PLANNING DEPARTMENT Town of Durham 8 Newmarket Road Durham, NH 03824-2898 Phone (603) 868-8064 www.ci.durham.nh.us

<u>Planning Consultant's Review</u> Planning Board Meeting – Wednesday, August 25, 2021

- VIII. Public Hearing Mill Plaza Redevelopment. 7 Mill Road. Continued review of application for site plan and conditional use for mixed use redevelopment project, drive-through facility for bank, and activity within the wetland and shoreland overlay districts. Colonial Durham Associates, property owner. Sean McCauley, agent. Joe Persechino, Tighe & Bond, engineer. Emily Innes and Sharon Ames, Harriman, project designer. Ari Pollack, attorney. (Rick Taintor is serving as the Town's Contract Planner.) Central Business District. Map 5, Lot 1-1.
- ➢ I recommend that the Board reopen the public hearing and vote to continue the hearing to a date to be determined.

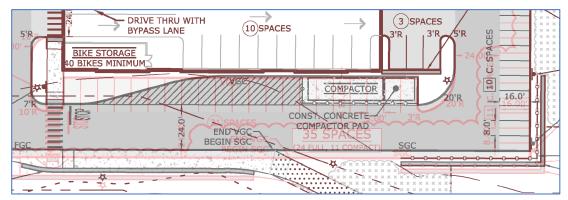
• Building B is shifted about 25 feet southerly (i.e., toward College Brook) in order to add a row of parking against the hillside near the Orion property.

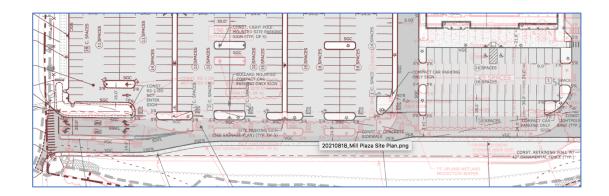
• The compactor facility is moved from the north side of Building C (tucked in the hillside) to the south side of the building.
